UNITED STATES PATENT AND TRADEMARK OFFICE

APPLICATION NO.	FILING DATE	FIRST NAMED INVENTOR	ATTORNEY DOCKET NO.	CONFIRMATION NO.
10/699,765	11/03/2003	John Gandy	20509.023	4233

Office Action Summary

DETAILED ACTION

App. No. 10/699,765
Reply to office action
of June 24, 2005
Annotated Sheet Showing
Drawing Changes

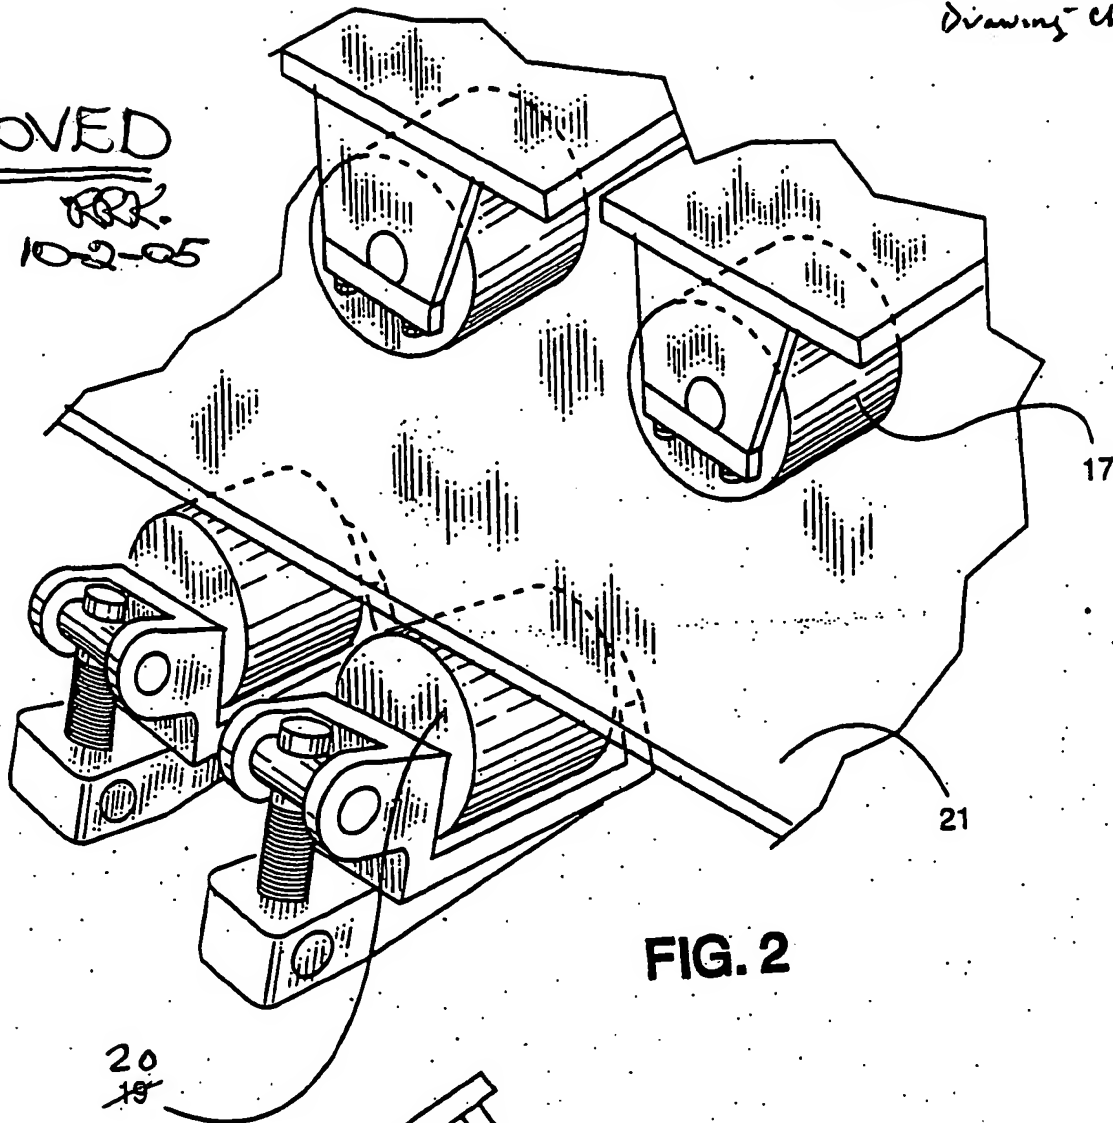
The drawings were received on August 31, 2005. These drawings are acceptable.

APPROVED
